August 4, 2010

**Re: Construction Storm Water Inspection at Bedford II Landfill Cover
Franklin County.
Permit Number: 4GC03047*AG**

Figure 1: Sediment laden waters leaving property, skimmer also requires maintenance.

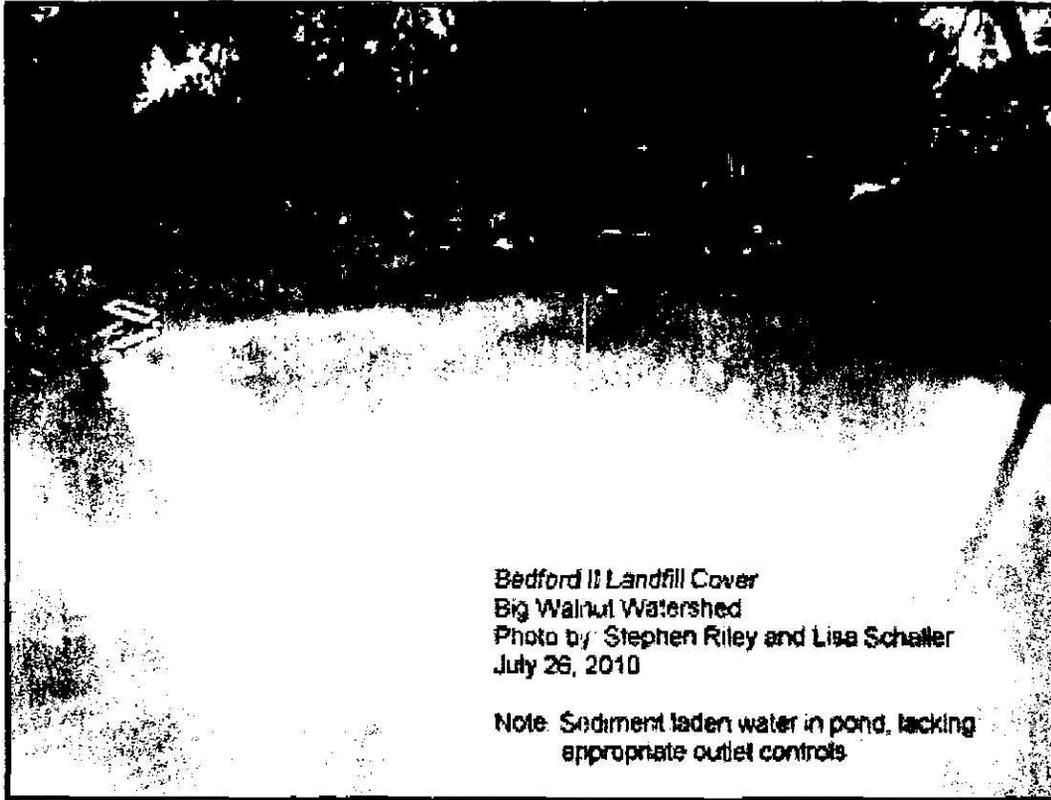
- Water collection inlets must be covered to minimize sediment flow off-site. (see figure 1).
- Skimmer must be maintained after storm events to ensure functionality. This was brought to your attention during our last inspection on April 7, 2010.
